APPLICATION NO.	FILING DATE	FIRST NAMED INVENTOR	ATTORNEY DOCKET NO.	CONFIRMATION NO.
10/825,633	04/15/2004	Gary Dilling	446-011602-US (PAR)	9000
2512	7590	05/02/2006	EXAMINER	
PERMAN & GREEN 425 POST ROAD FAIRFIELD, CT 06824			SHARP, JEFFREY ANDREW	
			ART UNIT	PAPER NUMBER
			3677	
DATE MAILED: 05/02/2006

Office Action Summary	Application No. 10/825,633	Applicant(s) DILLING, GARY	
	Examiner Jeffrey Sharp	Art Unit 3677

DETAILED ACTION

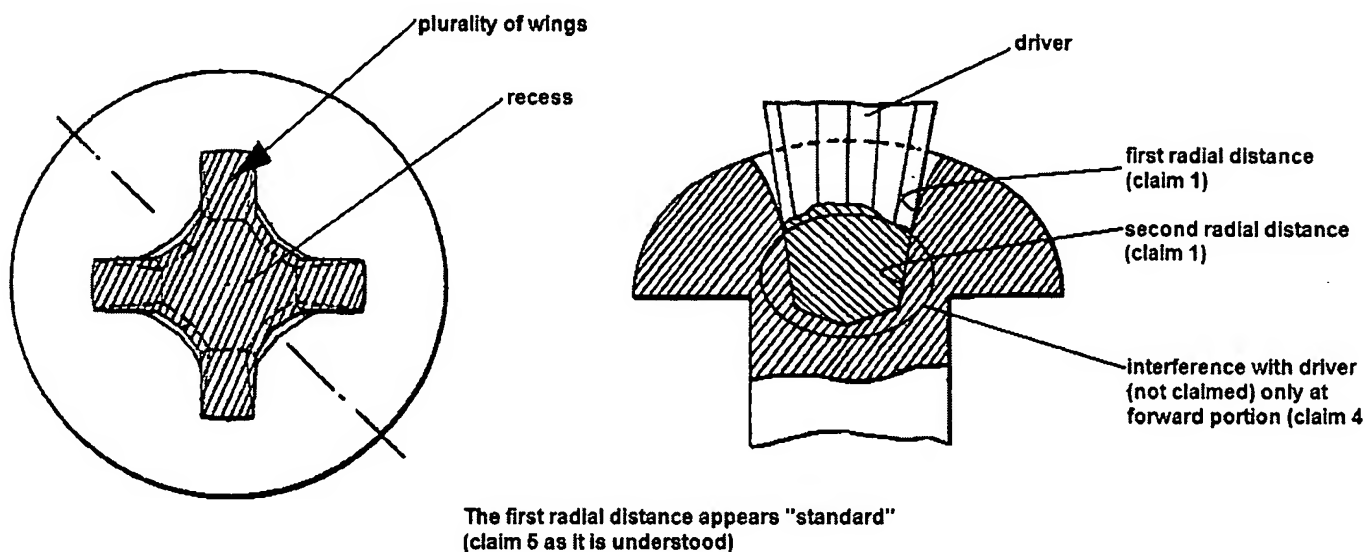
[9] Claim 5 is currently rejected under 35 U.S.C. 112, second paragraph, as being indefinite for failing to particularly point out and distinctly claim the subject matter which applicant regards as the invention.

It is unclear what a "*standard recess opening of a spiral type recess*" is.

Firstly, there appears to be no substantial definition of "standard recess opening of a spiral type recess". Therefore, no comparison of "*first radial distance*" with the present invention can be made. Secondly, it is not proper to include a standard in a pending claim, since standards are subject to change.

Lastly, the term "spiral type" is deemed synonymous with --spiral like-- and --spiral recess, or the like--. The phrase "or the like" renders the claim indefinite because the claim includes elements not actually disclosed (those encompassed by "or the like"), thereby rendering the scope of the claim unascertainable. See MPEP § 2173.05(d).
